REGIONAL REVIEW NOTICE

ARC REVIEW CODE: R1512221

Name of Proposal: Centennial Park North II

CENTENNIAL PARK NORTH II DRI – Notification Only
City of Atlanta
ARC Transportation Access & Mobility Division Review – Comments
December 21, 2015

SITE PLAN
CENTENNIAL PARK NORTH PHASE V-B
LL 79, 14TH DISTRICT, CITY OF ATLANTA, FULTON COUNTY, GEORGIA

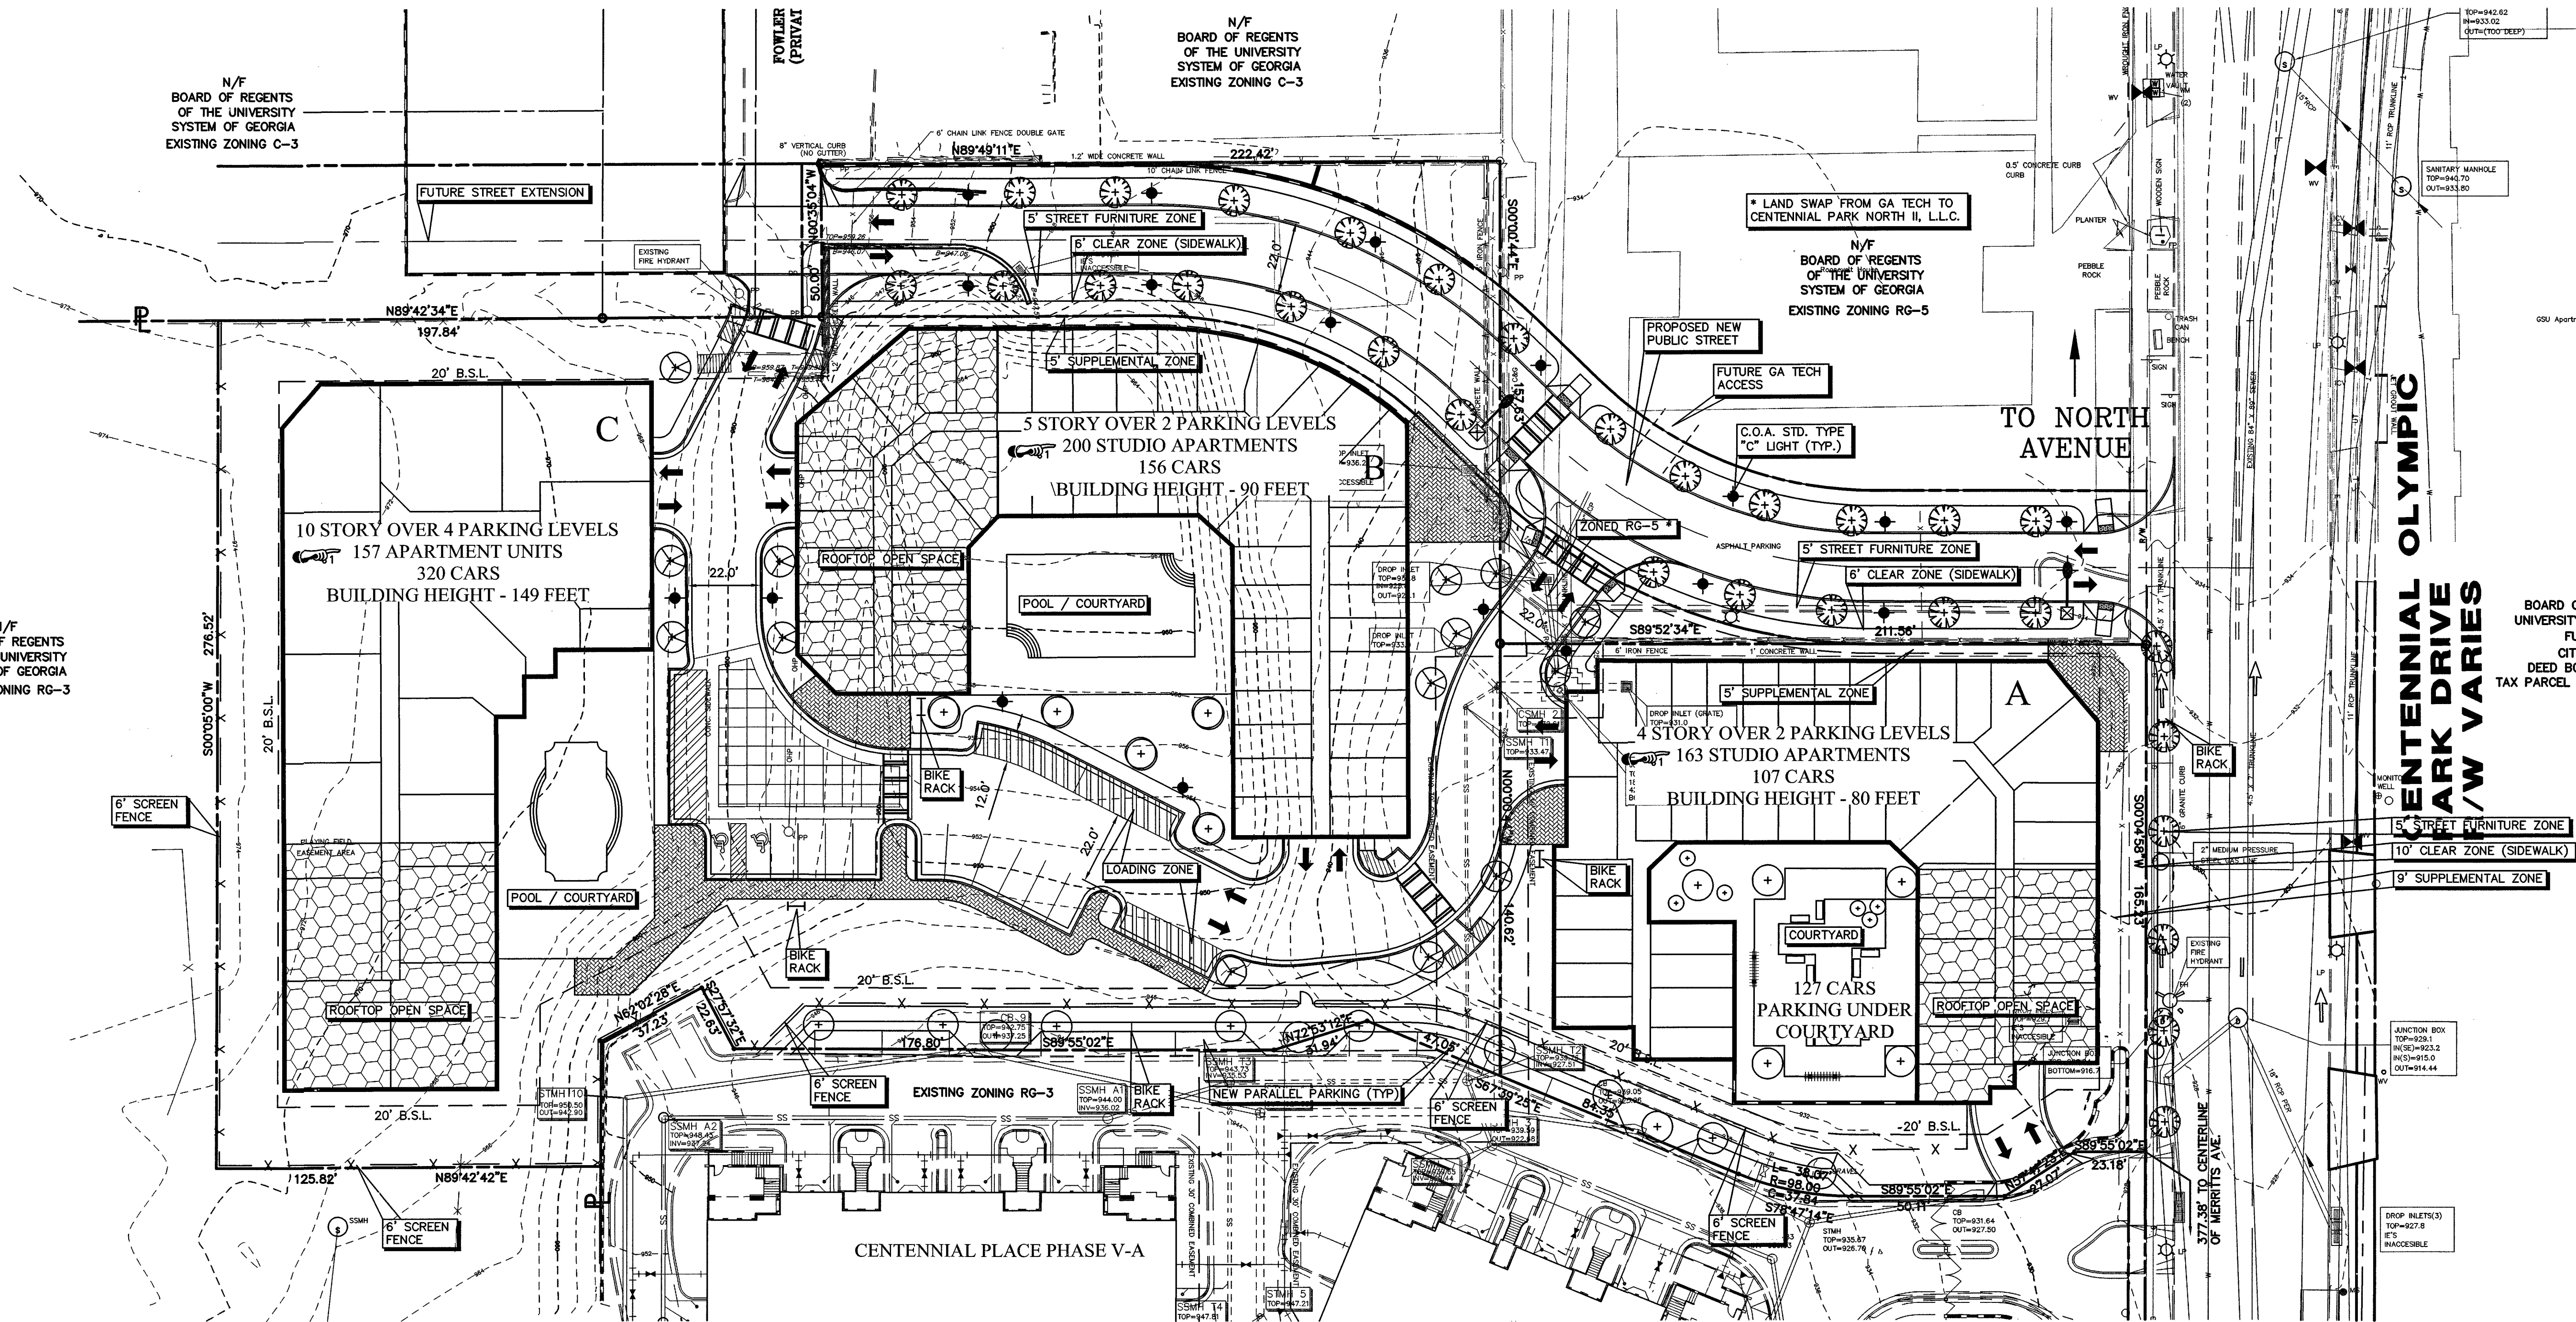
1. At the intersection of the Proposed New Public Street at Fowler Street, recommend re-designing the site driveway so it approaches the intersection at a 90 degree angle.

2. The driveway connecting from Building A to the driveway for Centennial Park North is too close to Centennial Park Drive. This driveway will create conflicts between drivers entering and exiting both developments. Additionally, vehicles exiting Building A may attempt to exit via the entrance lane for Centennial Park North. Due to these potential conflicts, recommend either removing the driveway connection between Centennial Park North and Building A or changing this driveway to entrance only for Building A.

3. At the intersection of Centennial Olympic Park Drive and the Proposed New Public Street, recommend changing the eastbound approach to two lanes – a left-turn lane and a right-turn lane. If the Proposed New Public Street lines up with the entrance driveway for the existing development on the east side of Centennial Park Drive, then recommend the eastbound approach consist of a left-turn lane and a shared through/right-turn lane.

4. At the intersection of North Avenue at Centennial Olympic Drive, recommend adding “No Right Turn on Red” signage on the northbound approach. Also recommend adding a right-turn overlap phase on the northbound approach to allow the right-turn movement during the westbound protected left-turn phase.

5. Recommend adding a loading zone for building A. There are two zones close to building B, one of which may be intended to serve building A but may not operate as intended.

6. The number of proposed parking spaces is significantly greater than the required minimum parking spaces. Recommend to reduce the number of parking spaces where possible. A clarification on the number of 1-bedroom and 2-bedroom units in building C may help.

7. Recommend adding secure and safe bike parking inside of the parking garages.
8. Recommend adding electric car charging stations for residents.
